**SUPPLEMENTAL CLOSURE PLAN REPORT
SULLIVAN LANDFILL
SULLIVAN, MISSOURI**

SUPPLEMENTAL CLOSURE PLAN REPORT
SULLIVAN LANDFILL

2.0 RESPONSE TO MDNR COMMENTS OF FEBRUARY 25, 1993

**FIGURE 1
PLAN OF
LEACHATE COLLECTION
SULLIVAN, MO. LANDFILL**

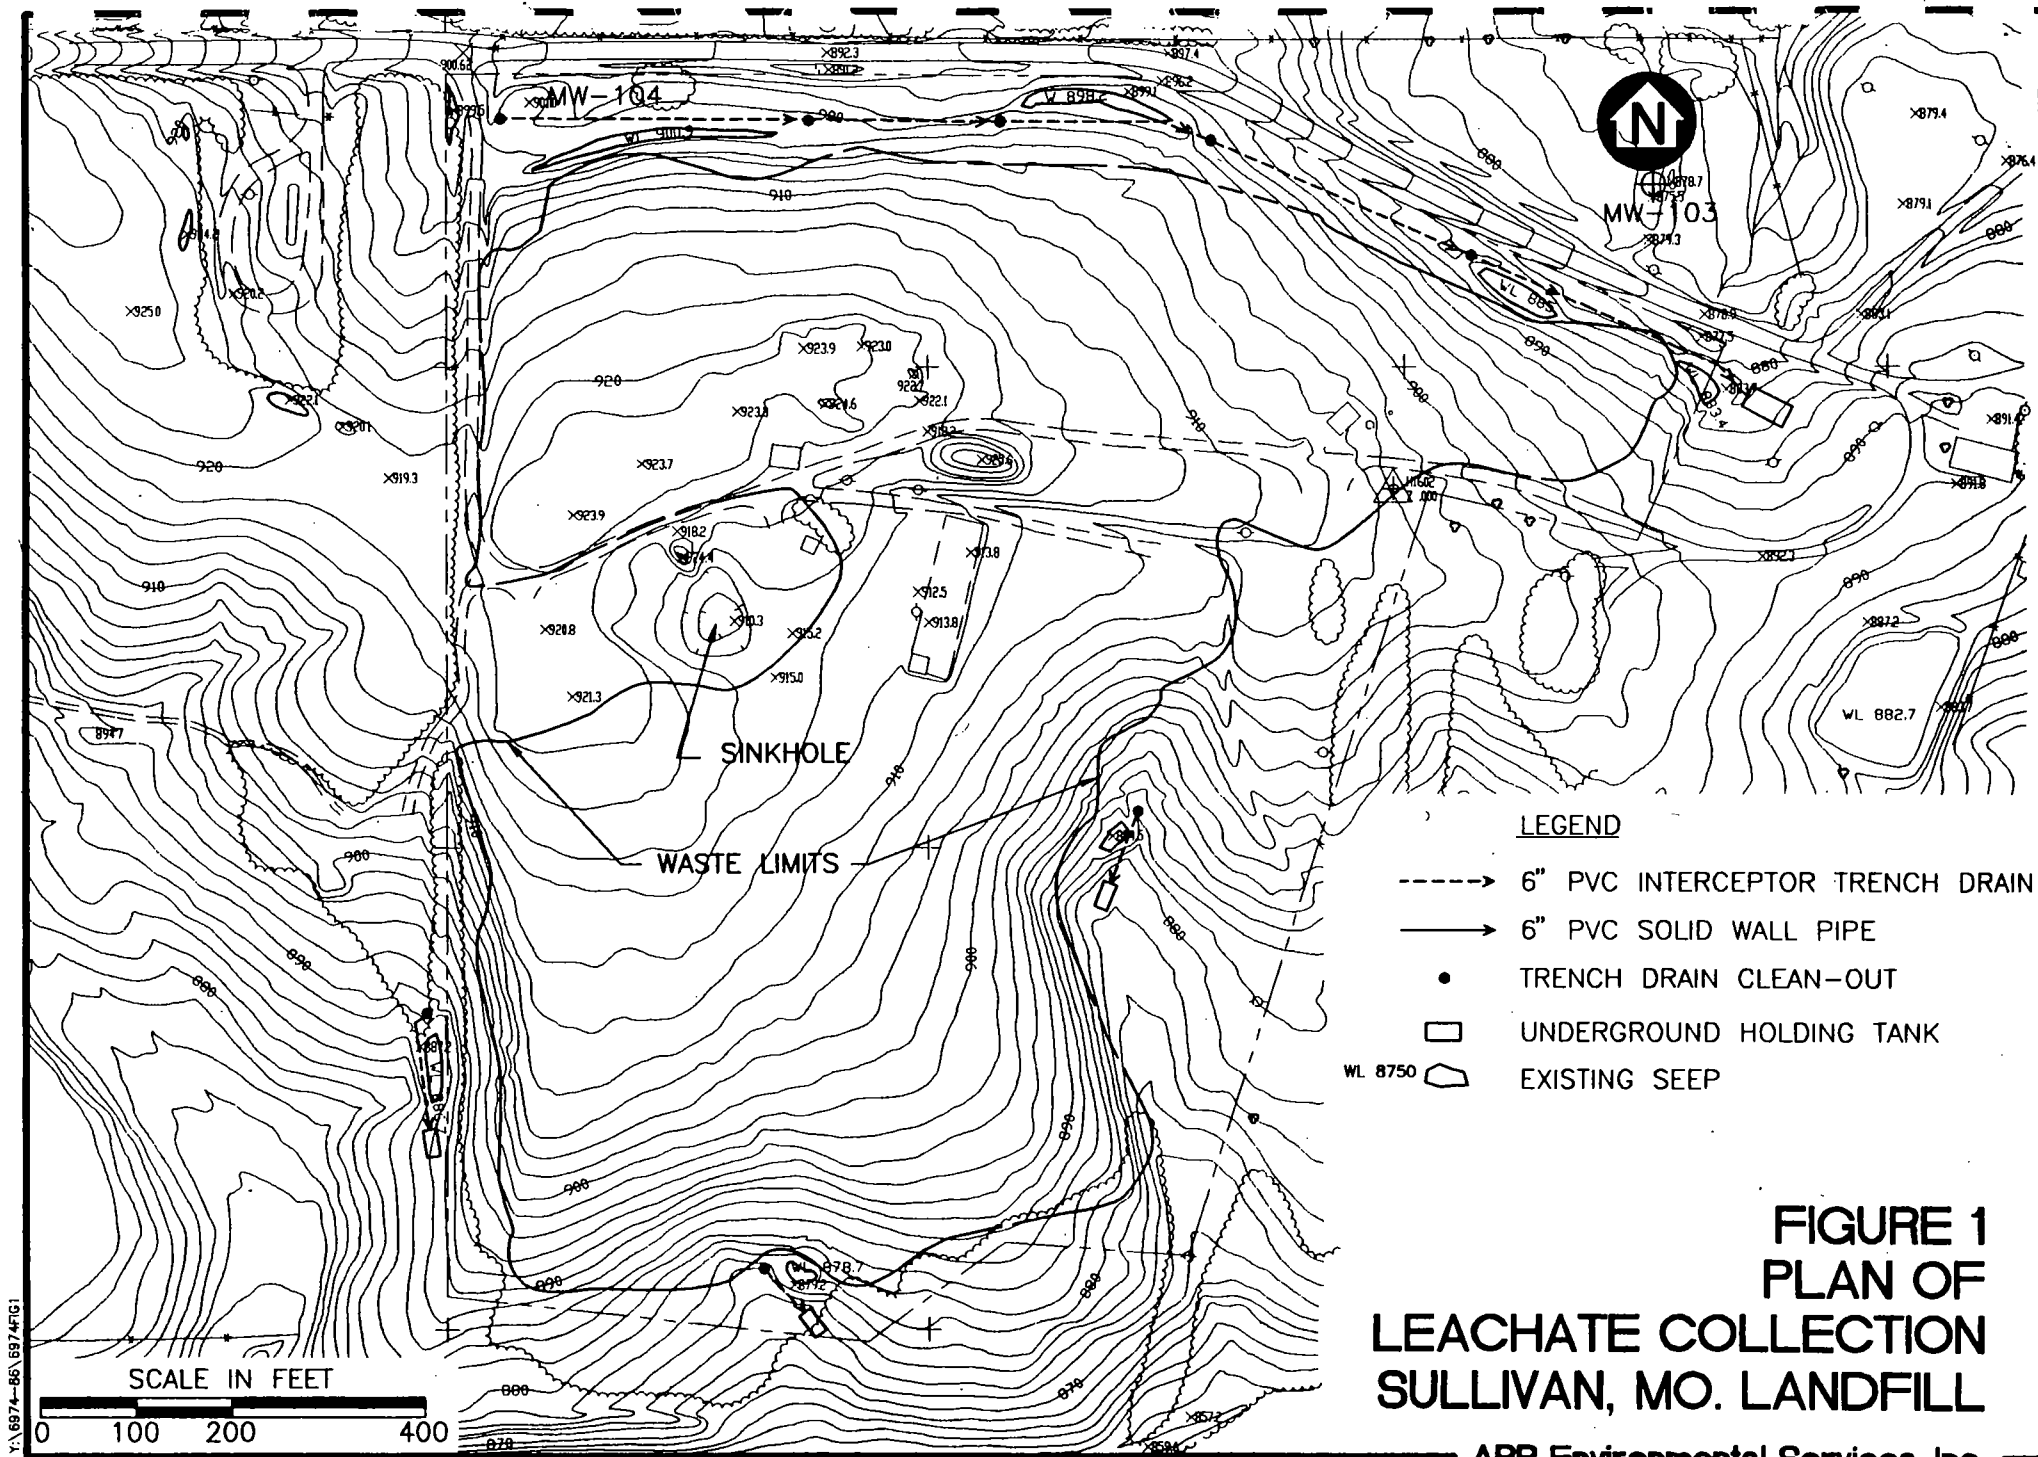
In the January 20, 1993 Closure Plan comments letter provided by MDNR to ABB-ES, a request was made to abandon the concept of passive leachate seep remediation after cap placement in favor of active collection and disposal. Although ABB-ES believes that the seeps will evaporate if left exposed subsequent to capping the landfill, the timeframe for complete passive seep remediation cannot be estimated with certainty. To comply with MDNR's request, ABB-ES proposes the following active leachate seep remediation plan.

After placement of the hydraulic barrier soil component of the landfill cap, the seven leachate seeps will be pumped into vacuum trucks and disposed offsite at a commercial wastewater disposal facility. Concurrent with this effort, a piping/holding tank system will be constructed to collect for disposal seep flows occurring after cap construction. An estimated seep volume equal to the volume currently contained by the seven seep ponds (approximately 200,000 gallons total) is predicted to continue to flow over a period of from six to twelve months after cap placement. (Estimated leachate seep rate calculations are provided in Appendix A).

The system to collect leachate seep water will consist of gravity piping and four holding tanks. The leachate seeps will be drained by gravity piping to four holding tanks buried at the locations shown in Figure 1. One tank will be dedicated to receive flows from Seeps 1 through 4, while Seeps 5 through 7 drain to one dedicated tank each. A geomembrane liner will be constructed below and downgradient from the perforated pipe trench as shown in Figure 2 to preclude leakage of seep liquid. Holding tank detail is shown in Figure 3. Each tank will be sized to hold, at a

FIGURE 4
SINKHOLE TEST PIT LOCATIONS
1 THROUGH 11
SULLIVAN, MO. LANDFILL
 ABB Environmental Services, Inc.

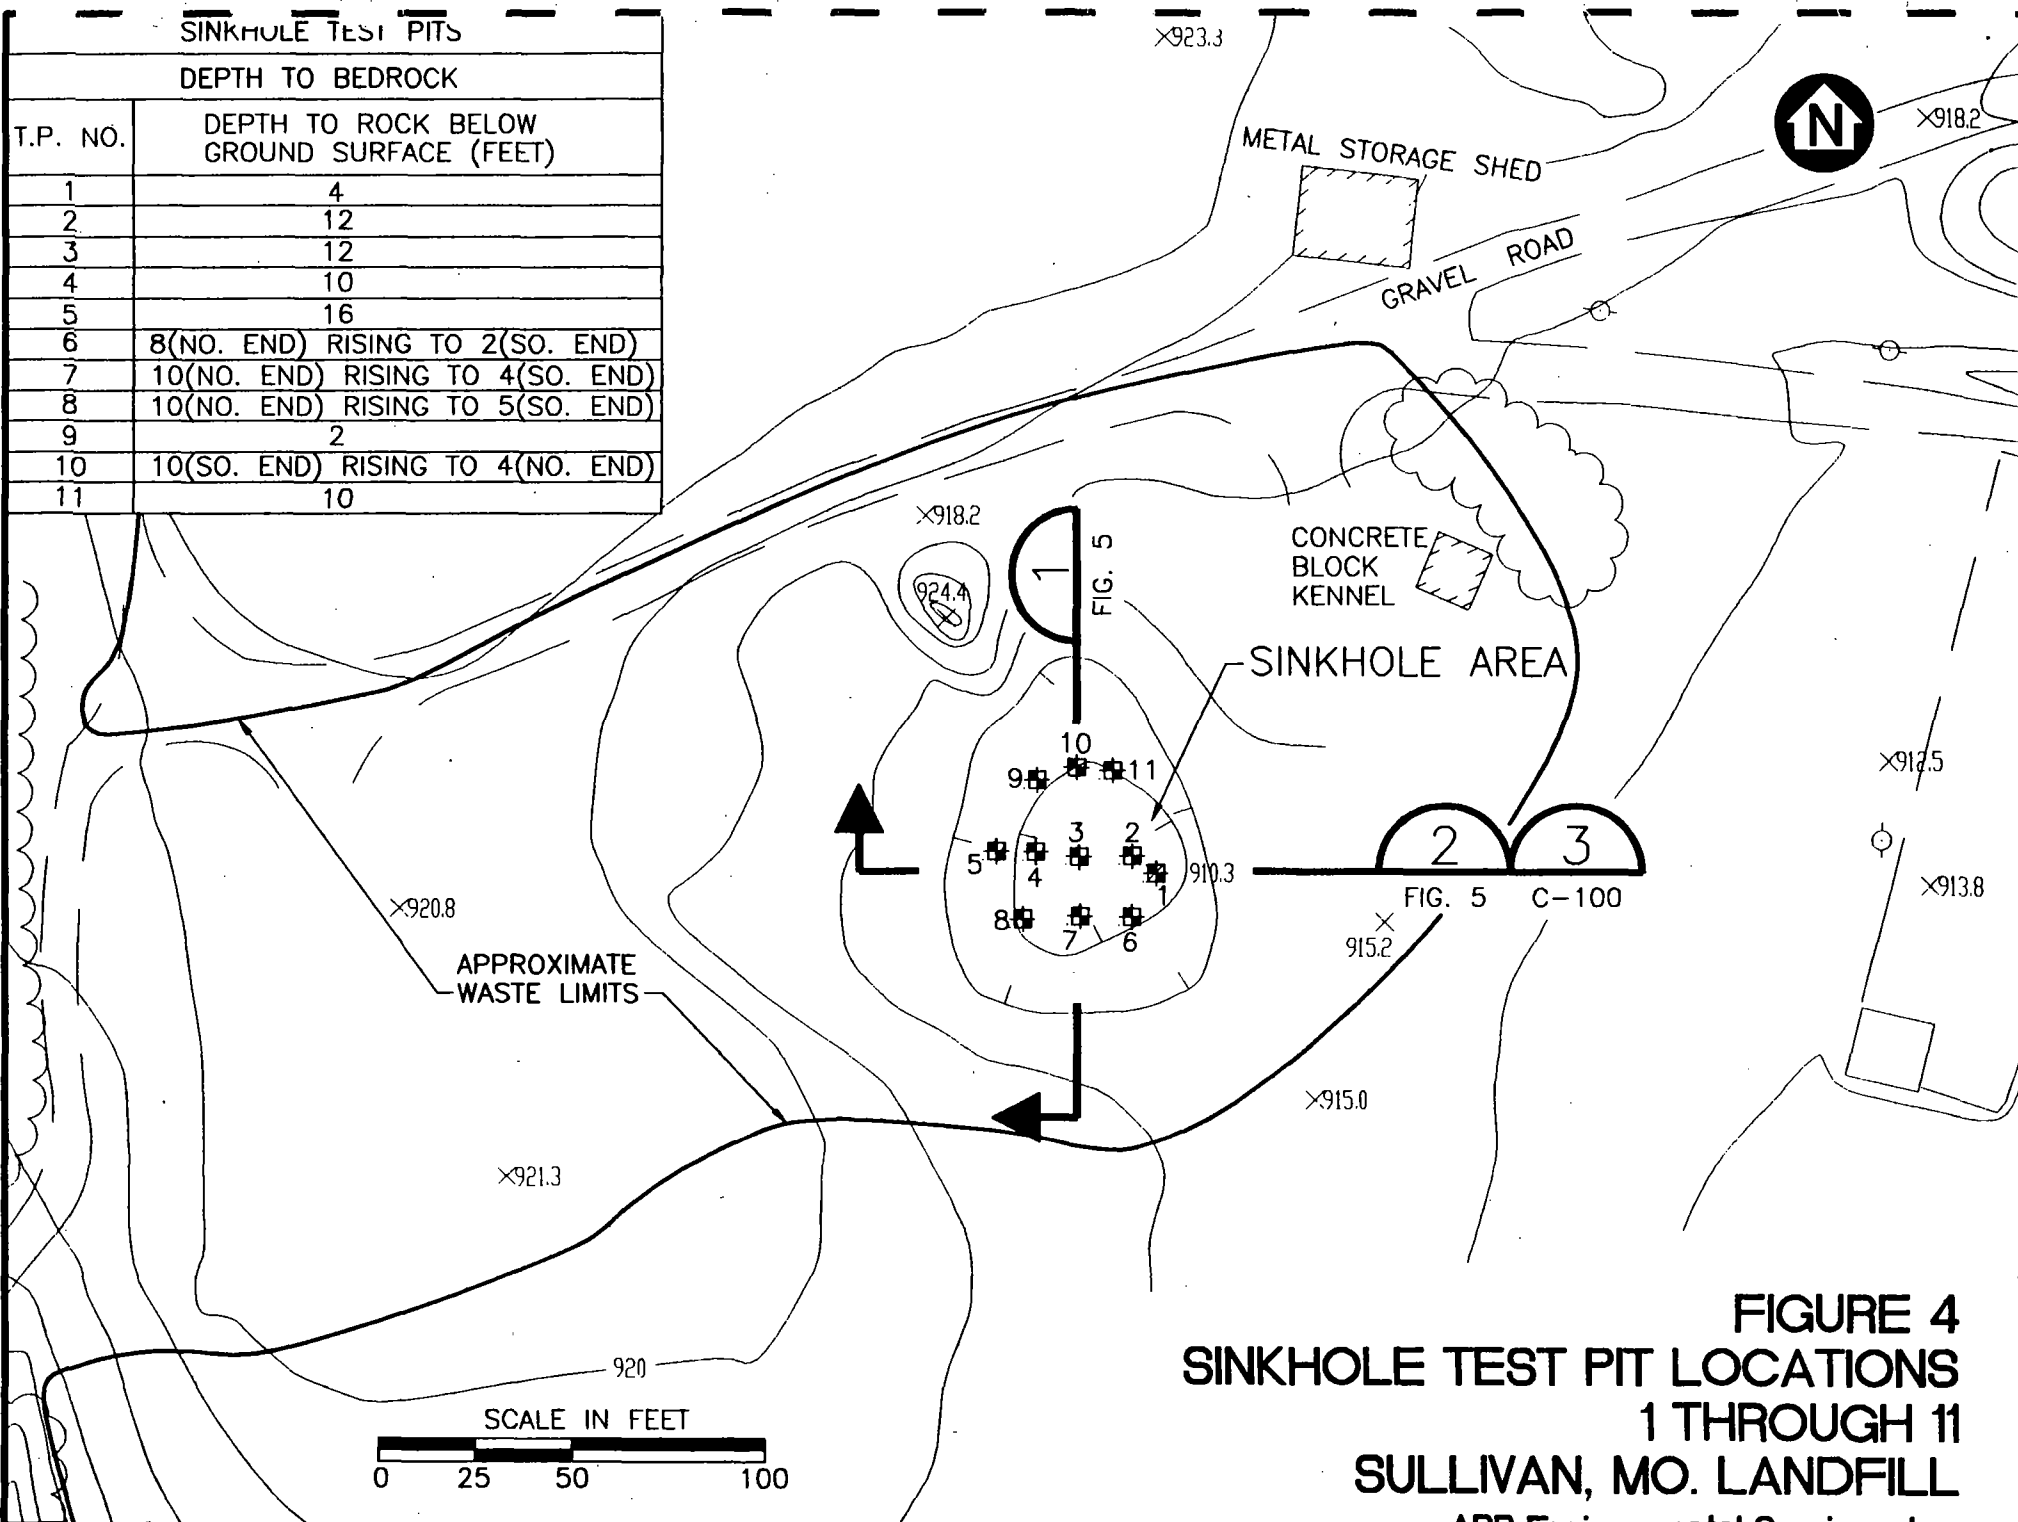
Upon review of the Draft Closure Plan, MDNR requested that more information be provided relative to treatment of the sinkhole during closure.

Test pits TP1 through TP11 were excavated at the locations shown in Figure 4. A varying two-to-four foot thick layer of wood ash was observed in most pits, as well as an occasional empty bottle or bit of household rubbish. The observation of wood ash is consistent with verbal reports by a former landfill operations worker that the sinkhole received wood wastes during landfill disposal operations. The eleven pits ranged in depth from two to 16 feet below ground surface (bgs). Bedrock was encountered at the bottom of each pit. Figure 4 summarizes depth to rock measured in each of the pits. Figure 5 shows east-west and north-south bedrock profiles. Profile orientation is shown in Figure 4.

FIGURE 7
SETTLEMENT PLATFORM
SULLIVAN, MO. LANDFILL

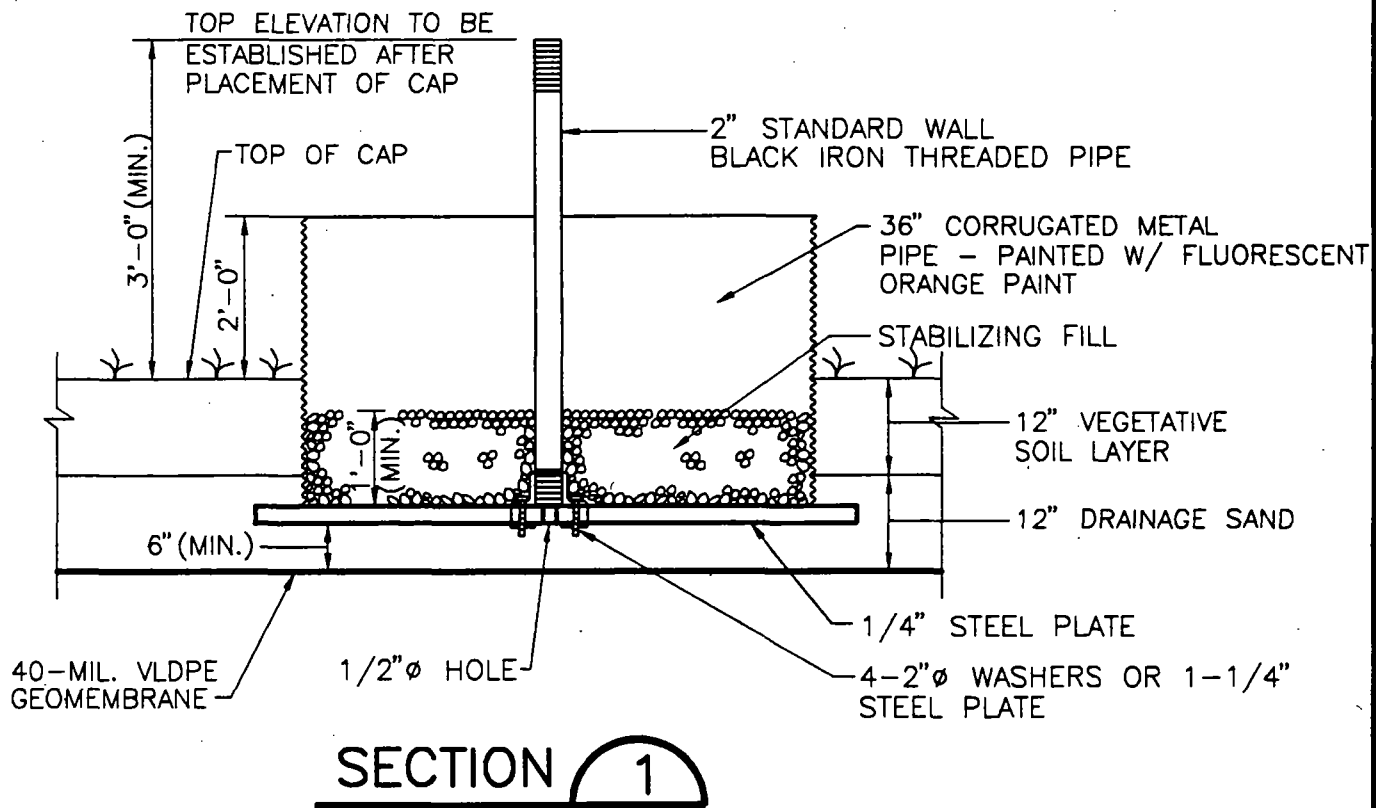
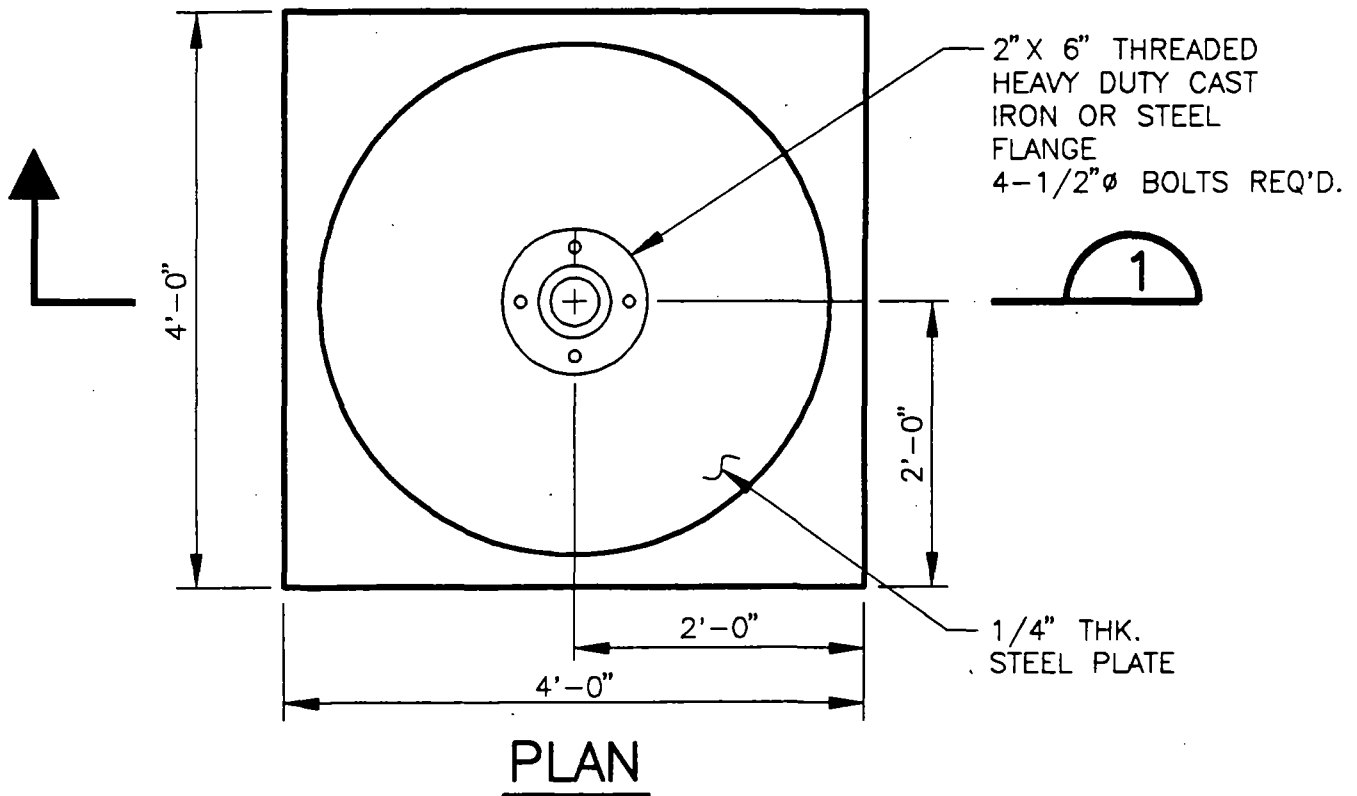
MDNR requested that more information be provided relative to landfill cap settlement monitoring during the post-closure monitoring and maintenance period.

Details of the proposed settlement markers and placement locations are shown in Figure 7 and 8, respectively. Settlement monitoring will be performed quarterly during the first year of post closure, semiannually for the following two years, and annually through the fifth post-construction year. Based on results to that point, recommendations will be made for frequency of future continued monitoring, if required.
